Item Number: 26A-BIK-01

## NCUTCD PROPOSAL FOR CHANGES TO THE MANUAL ON UNIFORM TRAFFIC CONTROL DEVICES

**COMMITTEE / TASK FORCE:** Bicycle Technical Committee  
**ITEM NUMBER:** 26A-BIK-01  
**TOPIC:** Bikeway Speed Limit Signs  
**ORIGIN OF REQUEST:** Bicycle Technical Committee  
**AFFECTED SECTIONS OF MUTCD:** 9B.24

Figure 9B-1 Regulatory Signs and Plaques for Bicycle Facilities

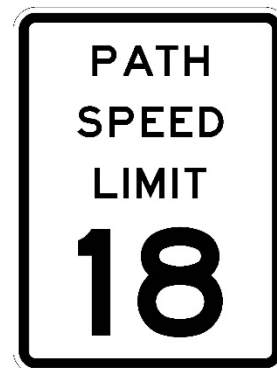
[Existing Figure 9B-1 in its entirety is omitted from proposal. Signs as shown below would be appended to signs in Figure 9B-1].

Where used, the Bikeway Speed Limit (R2-1a, R2-1b) sign (see Figure 9B-1) shall display the limit established by law, ordinance, regulation, or as adopted by an authorized agency based on an engineering study. The speed limits displayed shall be no less than 8 mph in multiples of 2 mph or 5 mph.
